18 June 2021

Re: DEVELOPMENT APPLICATION NO. DA/642/2020 – 11-19 FRENCHMANS ROAD, RANDWICK
APPLICANT'S RESPONSES TO COUNCIL REQUEST FOR INFORMATION AND DESIGN
EXCELLENCE PANEL COMMENTS
AMENDED DEVELOPMENT APPLICATION AND ADDENDUM STATEMENT OF ENVIRONMENTAL
EFFECTS

Table 1: List of Amended Documents and Appendices References

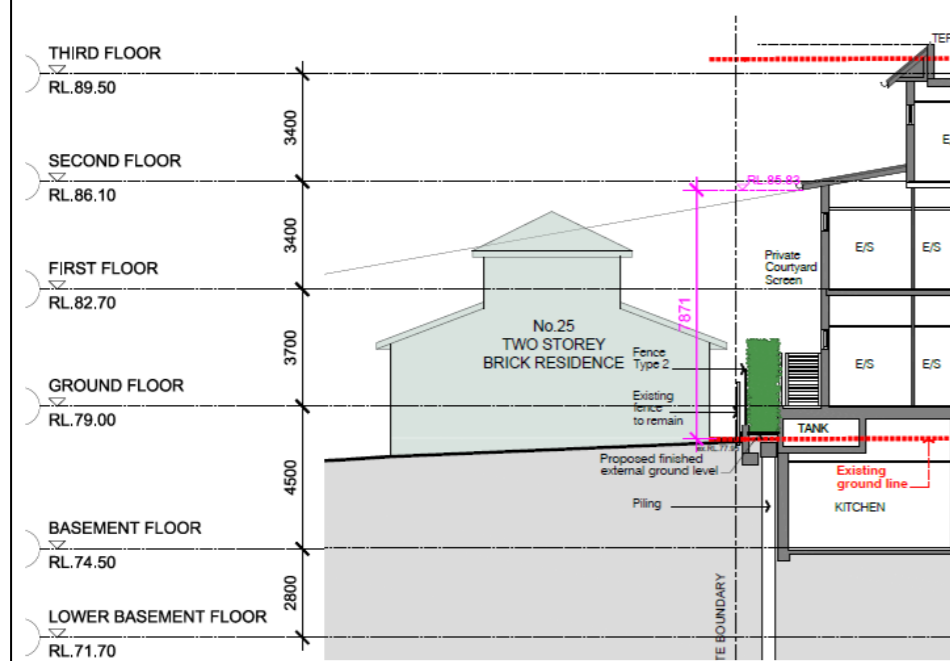
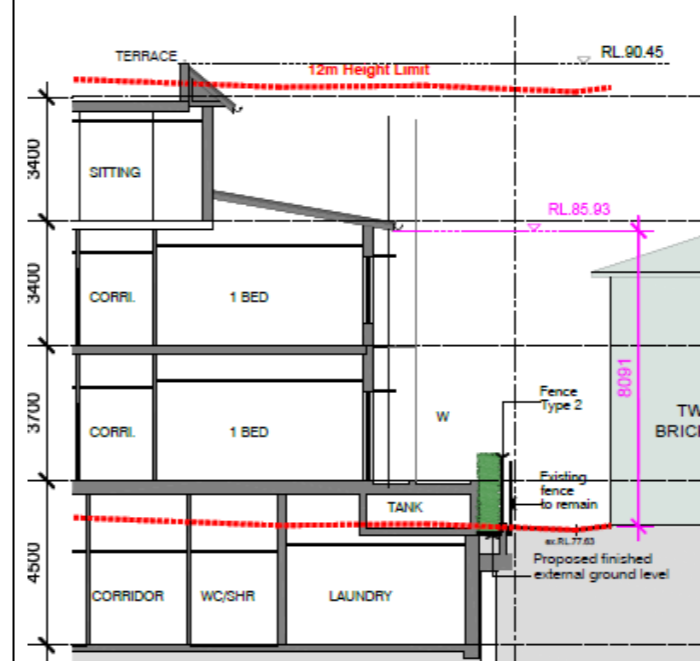
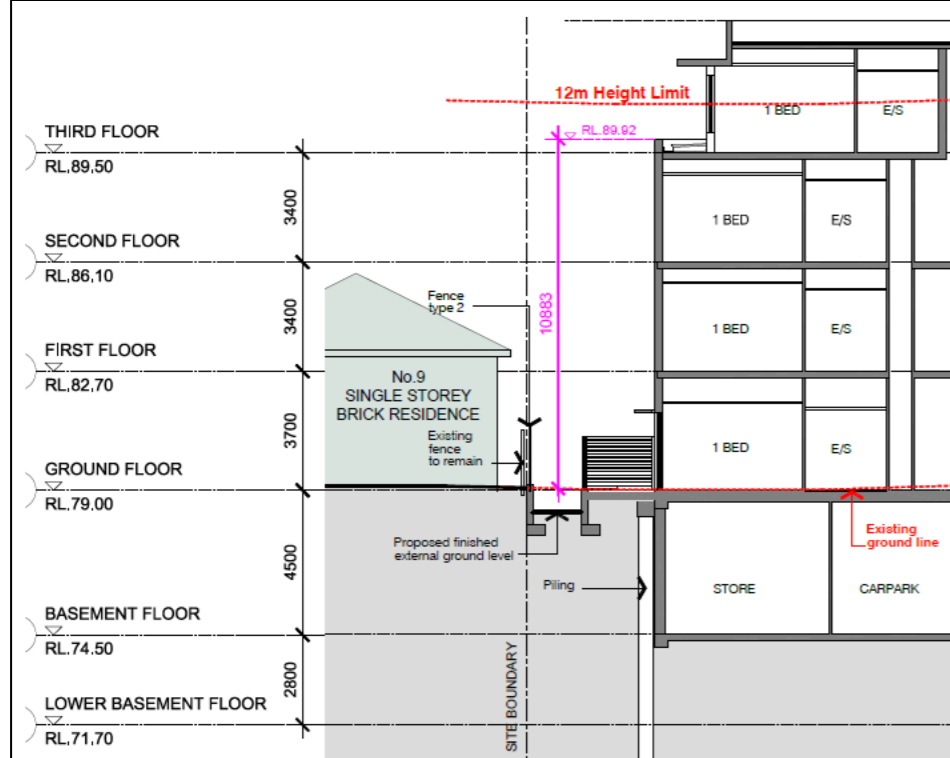
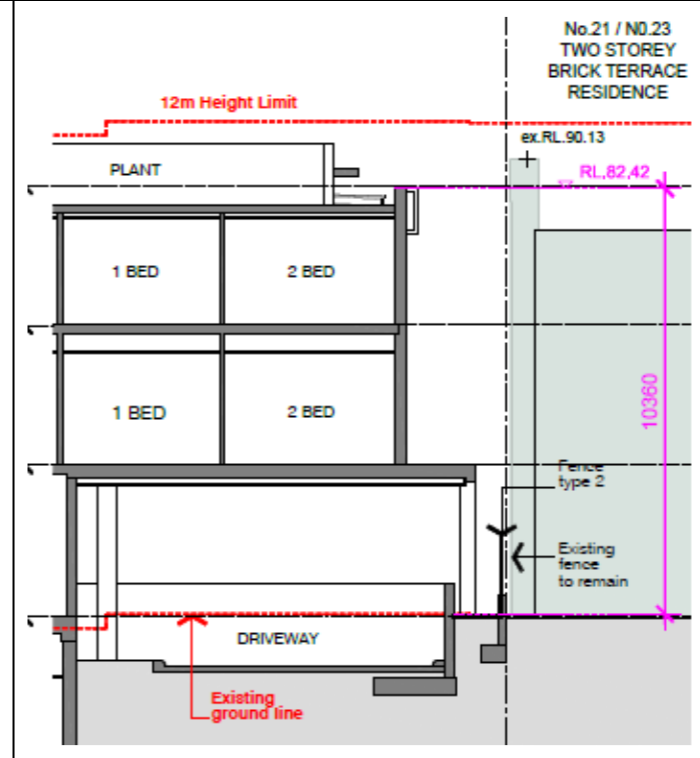
Original Architectural Design	Amended Architectural Design
No comparable drawing in original drawing set	
DA13a Sections @ Boundary Rev A dated 1 June 2021 – new drawing to demonstrate wall height adjacent to boundaries to respond to DEP comments	
 <p>Section G to eastern boundary with 25 McLennan Ave – wall height 7.871m setback 2.55m, upper level setback 3.95m</p>	 <p>Section J to western boundary with 27 McLennan Ave – wall height 8.091m setback 2.51m, upper level setback 3.96m</p>
 <p>Section K to western boundary with 9 Frenchmans Road – wall height 10.88m setback 4m, upper level setback 5.5m</p>	 <p>Section K to eastern boundary with 21 Frenchmans Road – wall height 10.36m setback 2.35m, upper level setback 3.85m to plant enclosure</p>
